Draft Bayside Development Control Plan 2022 (Post-Exhibition Report)

Attachment 6: Responses to Submissions Received

Map 32 in Sydney Airport's Master Plan 2039 illustrates the lighting restriction zones associated with each of the Sydney Airport runways. This map is reproduced below.

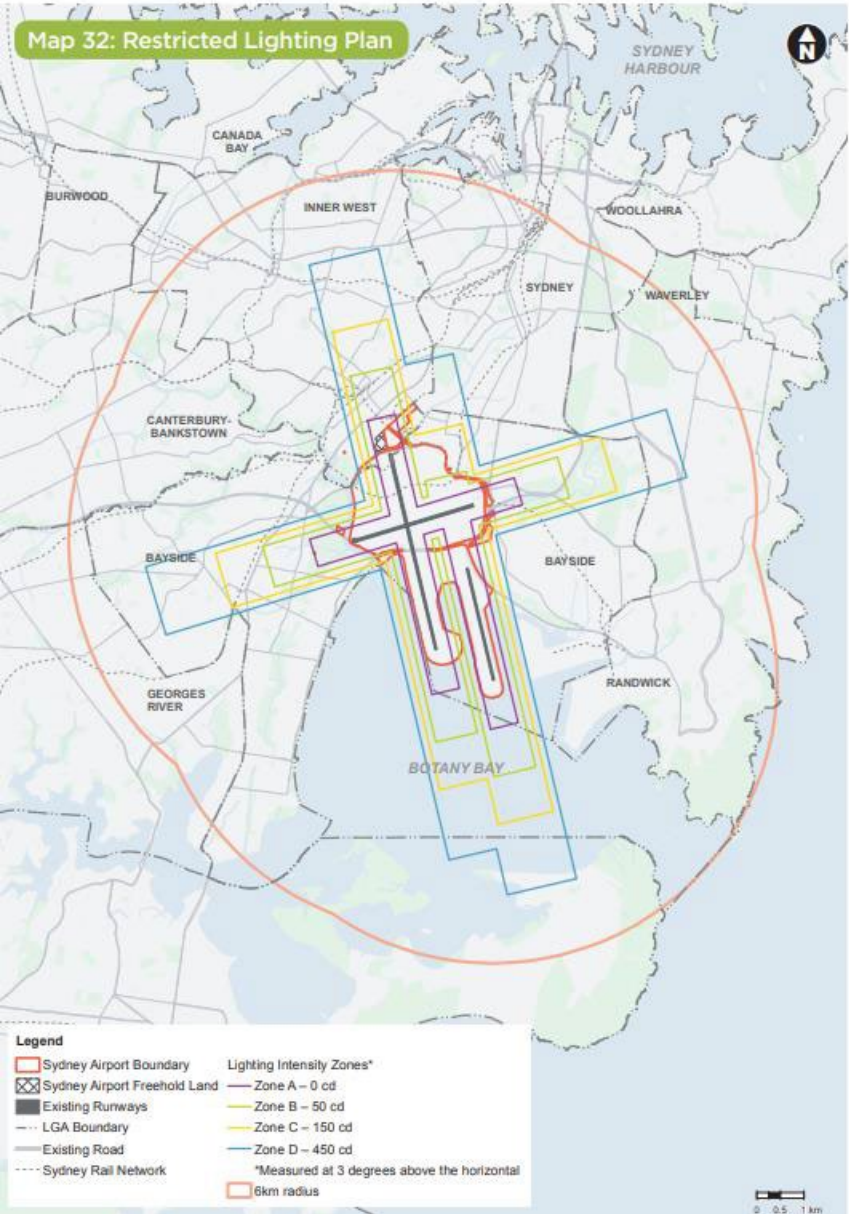
Recommend including new Objective O2:
To reduce the risk of distractions to pilots of aircraft from lighting and light fixtures near Sydney Airport.

Recommend new control C5:
National Airports Safeguarding Framework Guideline E – Managing Pilot Lighting Distraction should be referred to where relevant.
